SUBSURFACE WASTEWATER DISPOSAL SYSTEM APPLICATION

Town Or Plantation	AUGUSTA
Street Division Lot #	CHURCHILL ROAD

Subject: David Hall property, Churchhill Road, Augusta

SUBSURFACE WASTEWATER DISPOSAL PLAN

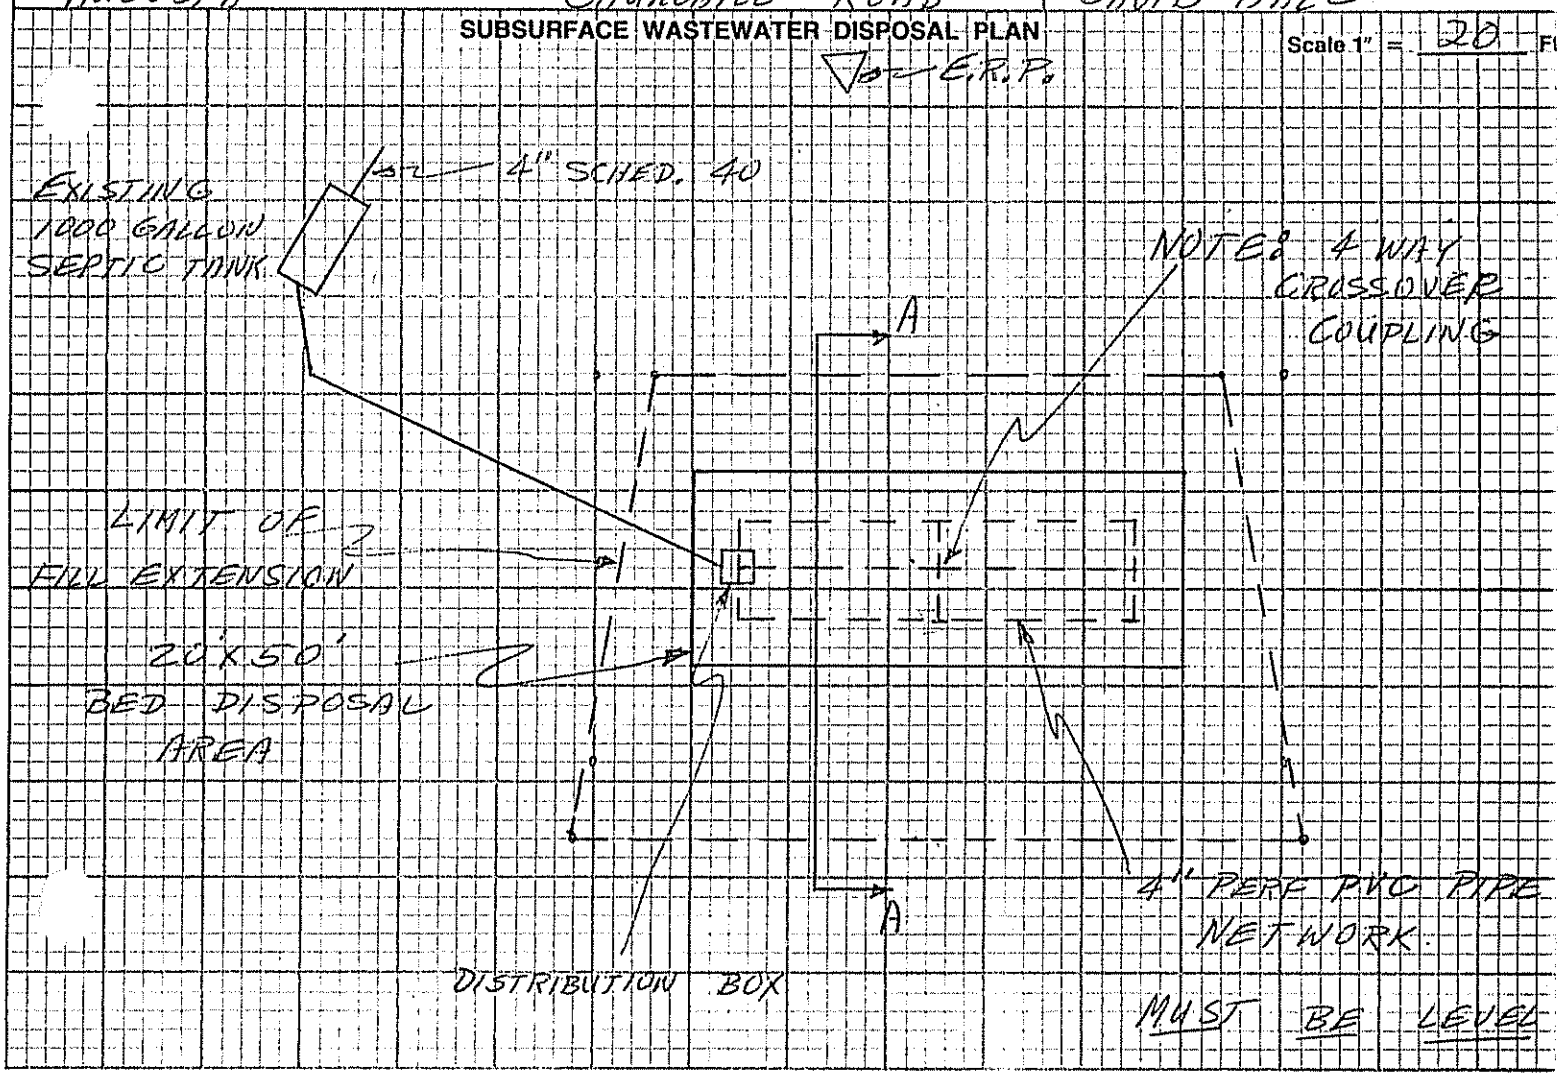
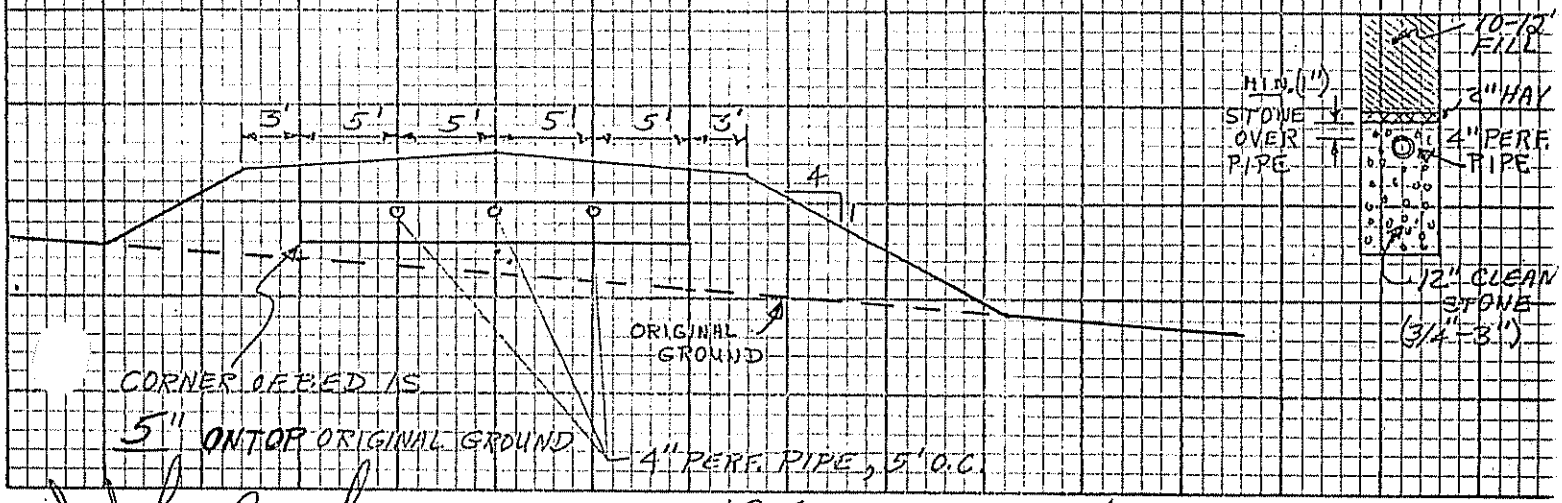
I have spoken with Mr. Brochu regarding the differences between his design and the system as built. These differences include the lack of a cross distribution pipe and 100 square feet of disposal bed. Mr. Brochu indicated he had no strong objections to acception of the system as built.

It would appear that the system as built meets or exceeds all design paramates of the rules. Therefore, if you are satisfied with the constitution of the system and all parties are satisfied with the size of the system you may issue a certificate of approval provided a revised plan is filed after the fact describing the system as-built.
